# **Sydney Metro West**

Hunter Street East Over Station Development  
Addendum to Transport and Access Report

**Document Number: SMWSTEDS-SMD-SCB-SN100-TP-RPT-044008**

Figure 1 Driveway access at O'Connell Street

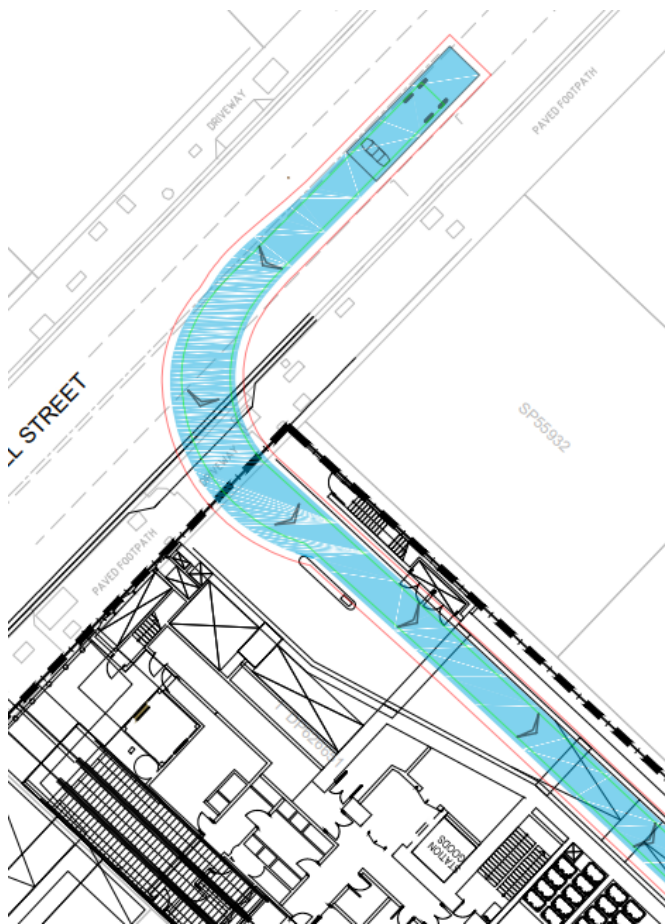
The reference design shows a two-way driveway across the O'Connell Street footpath, with very wide splayed kerbs. Any driveway should be perpendicular to the kerb to minimise impact on the pedestrian footpath. The proposal should also reflect the opportunity to close O'Connell Street at Hunter Street, as shown in the draft City North Public Domain Plan.

Swept path analysis has been updated to show right only exit in response to the objectives of the City North Public Domain Plan (Appendix A).

Both the exit and entry movements from the site are perpendicular to the kerb at the footway crossing, as shown in 1.

**Figure 2 Comparison of Fruin and Walking Space Guide Criteria**

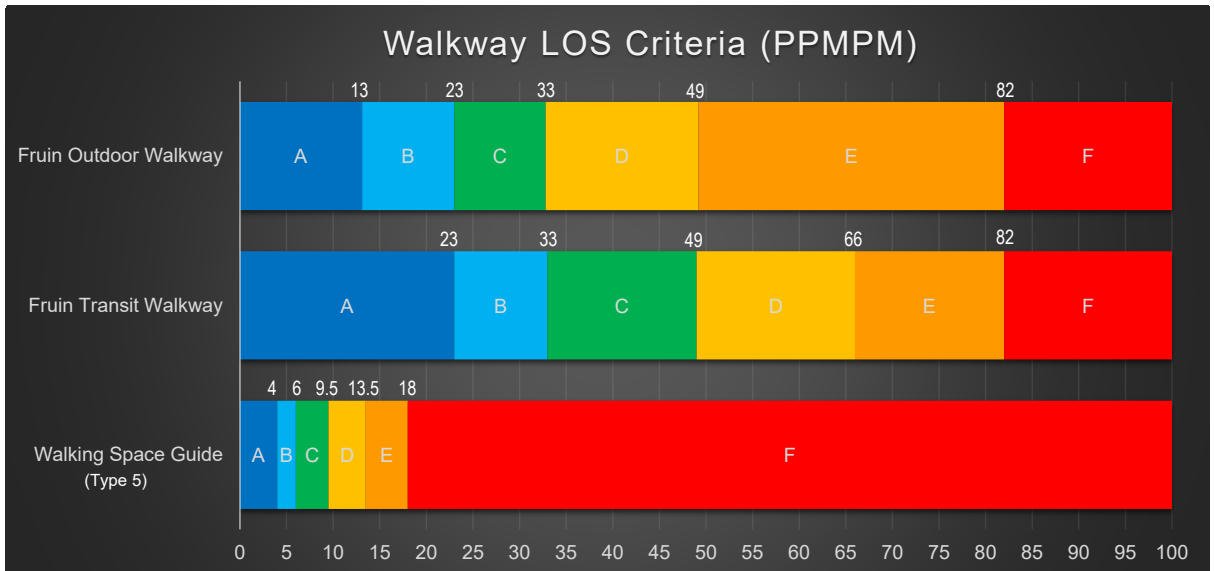
The City strongly objects to the use of Fruin for assessing footpath performance on Hunter Street and surrounds. This is an issue that the City has raised multiple times in previous submissions on the CSSI applications as well as during consultation meetings with Sydney Metro.

The City reiterates that the Walking Space Guide (WSG) published by TfNSW in 2020 at <https://standards.transport.nsw.gov.au/search-standard-specific/?id=TBA%20-%200003173:2022> is appropriate NSW standard for footpaths external to buildings in the public domain. It is misleading to imply that these footpaths are 'interchanges'. This leads to an under provision of walking space, crowding issues and safety concerns.

Sydney Metro argues that TfNSW's WSG is not fit for purpose as it shows poor performance for current conditions. The City's position is that this is an accurate representation of existing conditions and a reason for intervention and road space reallocation, not a reason to ignore the issue by using a metric more suited to crowded station conditions.

The proposal used the Fruin Outdoor Walkway Criteria to assess footpath performance. Nearly all footpaths are forecast to operate at LOS C or better using this performance criteria. The exception is the southern footpath of Hunter Street, west of Pitt Street. This section would operate at LOS D, with or without SMW, or this OSD. The Fruin Outdoor

Walkway criteria used is standard practice and considered appropriate for assessing conditions around a metro interchange.

We understand that the City of Sydney is requesting a reassessment of the footpath performance using the Walking Space Guide (WSG) criteria. This aspirational criterion is significantly more onerous than the Fruin criteria and may be more appropriate when applied to a greenfield development context. A sample comparison of the Fruin Walkway scales and the WSG, for Type 5 walkways, is provided in Figure 2.

# Appendix A Swept path analysis

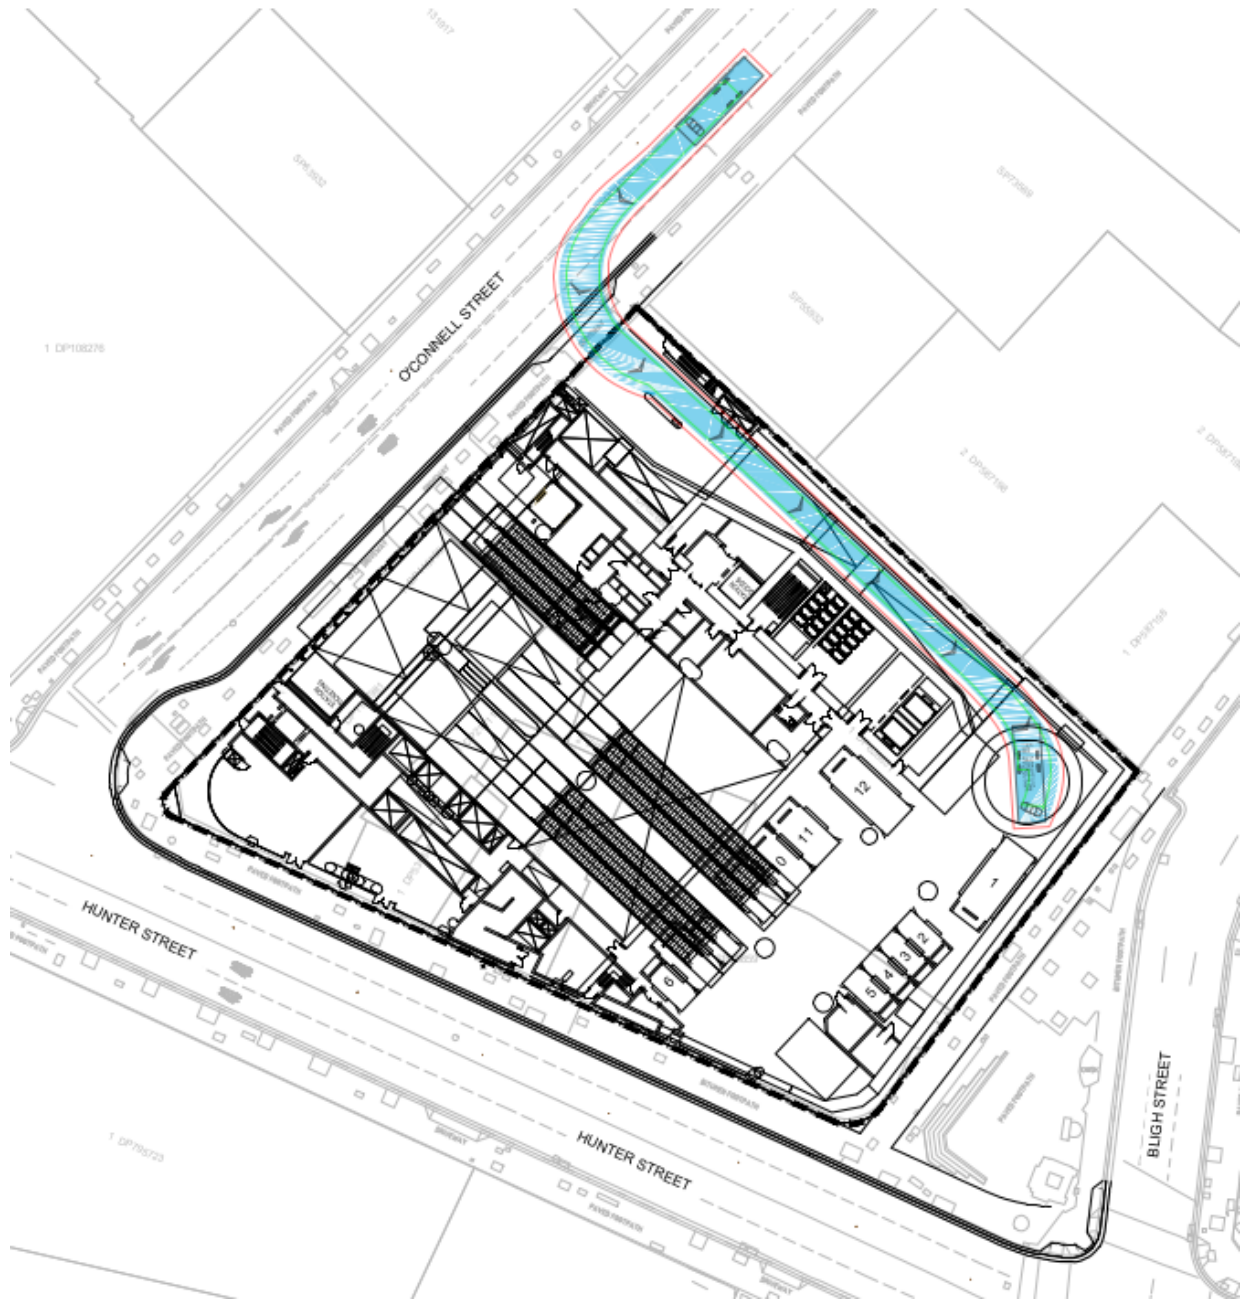
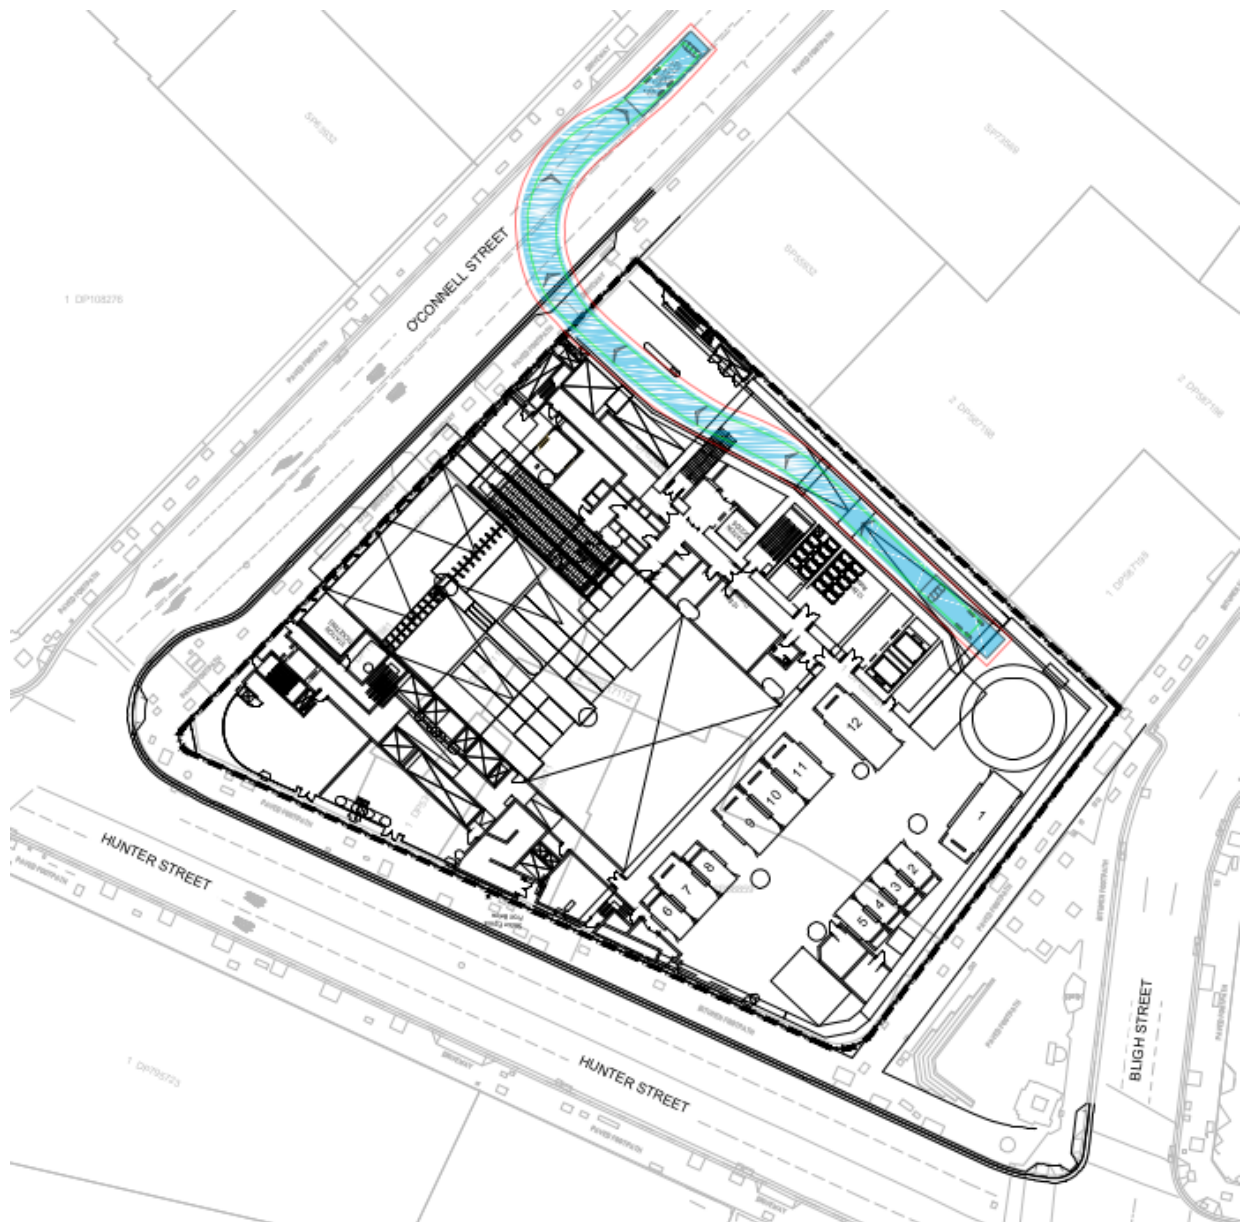
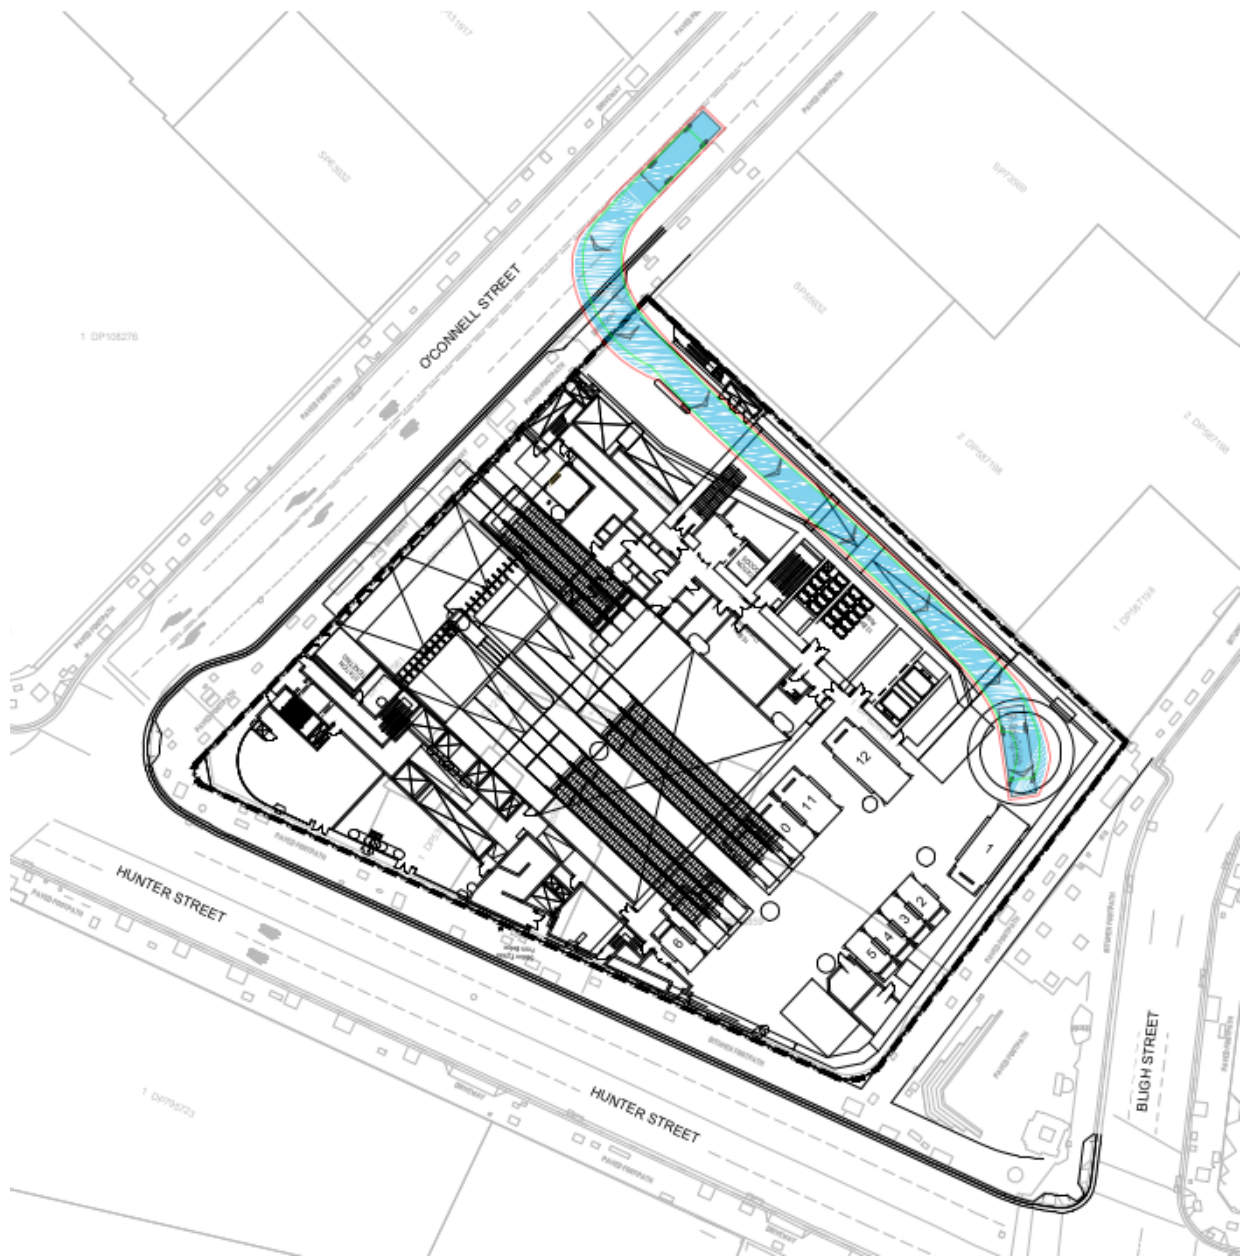
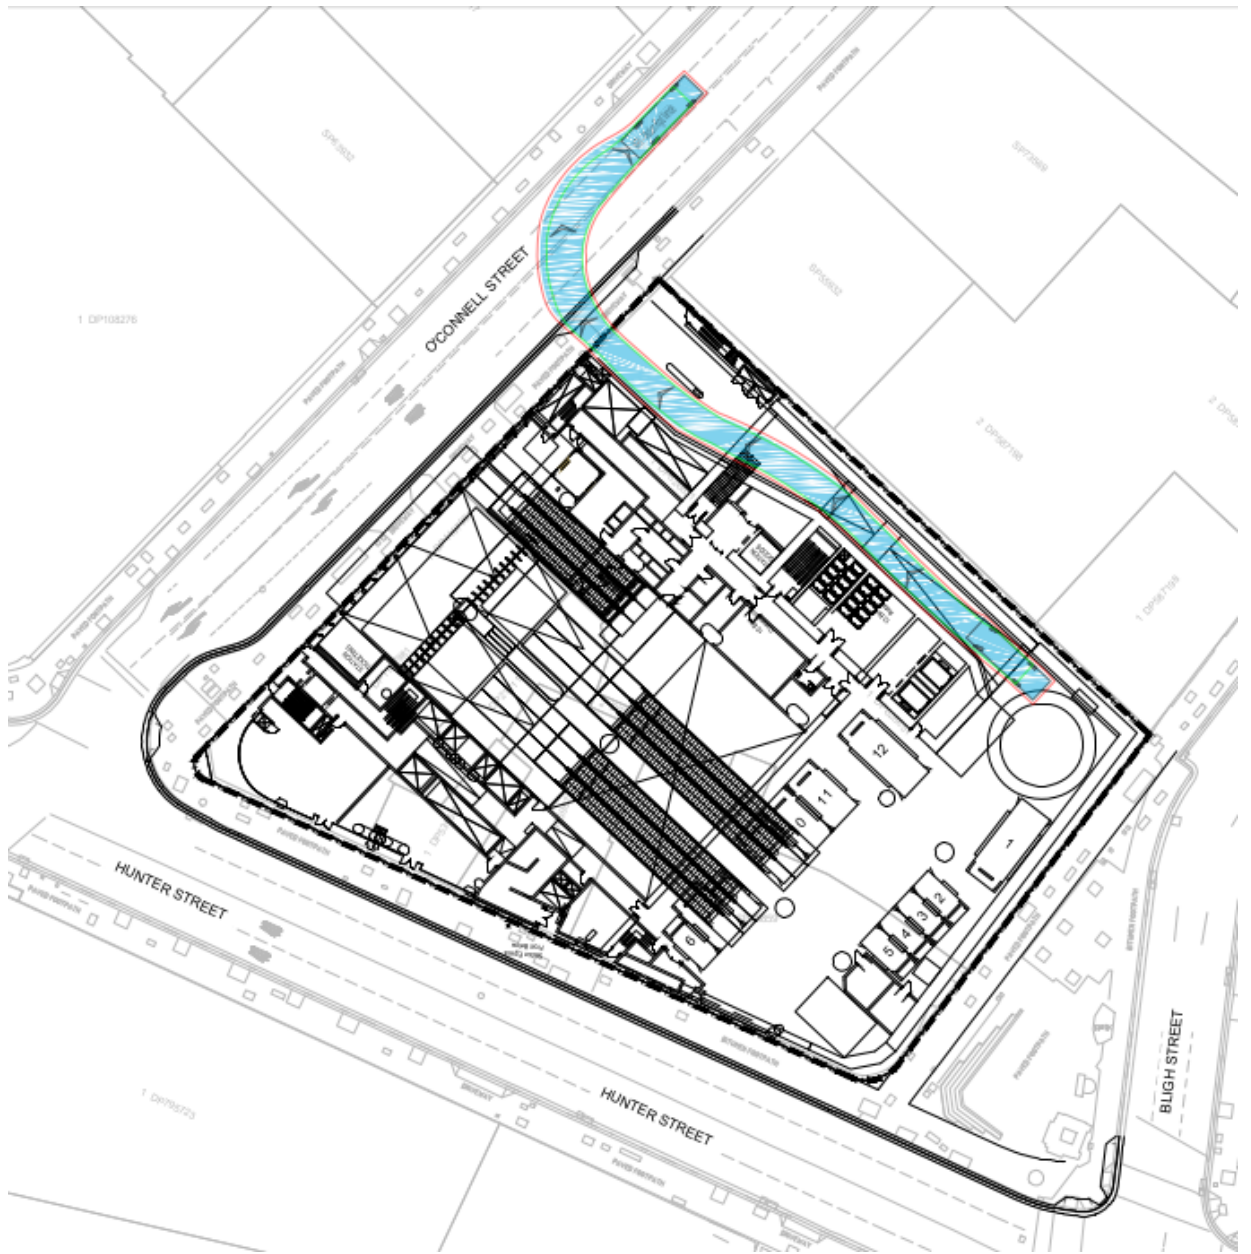
Section 5.2.3 Vehicular Access of the Transport and Access Report shows left-out and left-in movements. This section should acknowledge that the draft City North Public Domain Plan includes the ambition to close O'Connell Street at Hunter Street and make O'Connell Street two-way. This change would mean that vehicle access would also need to change from left-in left-out as depicted in Figure 5-3 to left-in right-out.

The swept path assessments for the OSD loading dock entry have been updated accordingly and are included in Appendix A.

We have considered the vehicular impacts at O'Connell Street. Revised swept path analysis for the operation of the OSD has been completed to acknowledge O'Connell Street closed north of Hunter Street and O'Connell Street. This has been included in Appendix A.
